SUNDRY NOTICES AND REPORTS ON WELLS

Escrito Gallup Unit #6

Plug and abandon per attached procedure.

CONDITIONS OF APPROVAL

Elizabeth 2 (EGU#6)
 Sec. 18-T24N-R7W
 Rio Arriba County , New Mexico
 BHL: 930' FNL, 1650' FWL
 Drilled by BCO Inc.

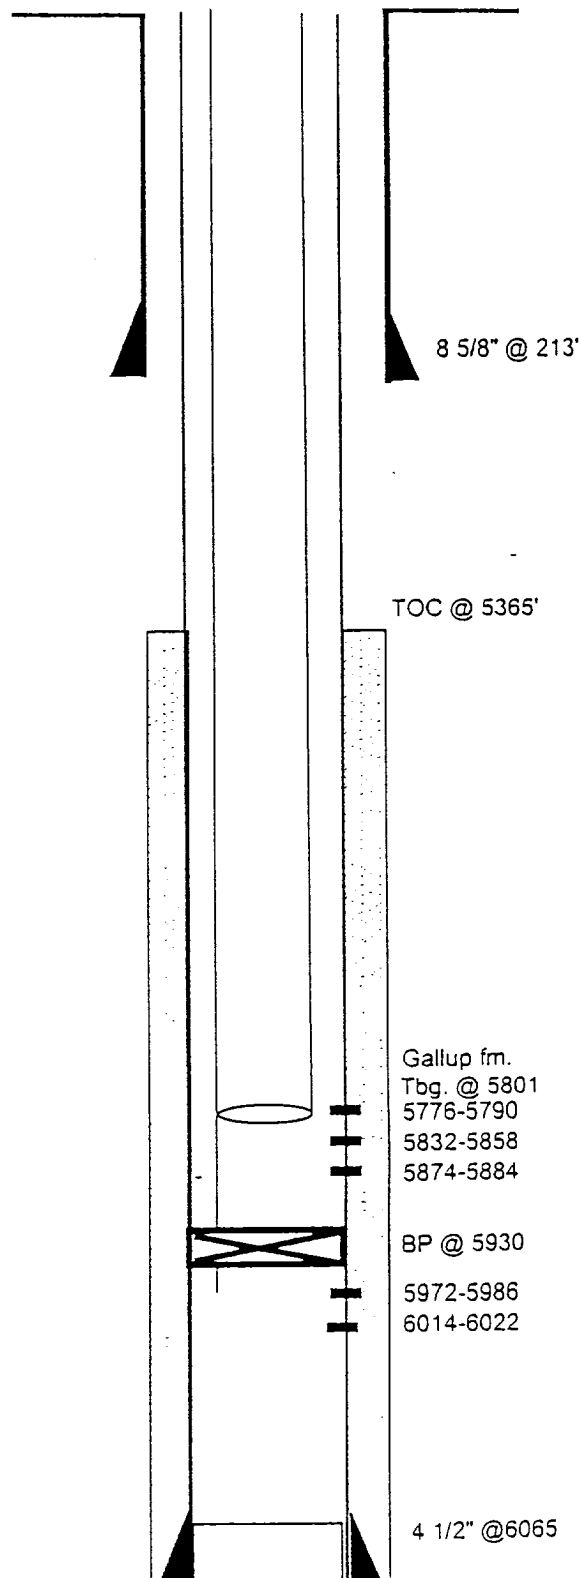
3. The following modifications to your plugging program are to be made:

- a) Bring the top of the Gallup plug to 5350'.
- b) Place the Pictured Cliffs/Fruitland plug from 2462' - 2100' inside and outside the 4 ½" casing.
- c) Place the Kirtland/Ojo Alamo plug from 1970' - 1660' inside and outside the 4 ½" casing.

You are also required to place cement excesses per 4.4 of the attached General Requirements.
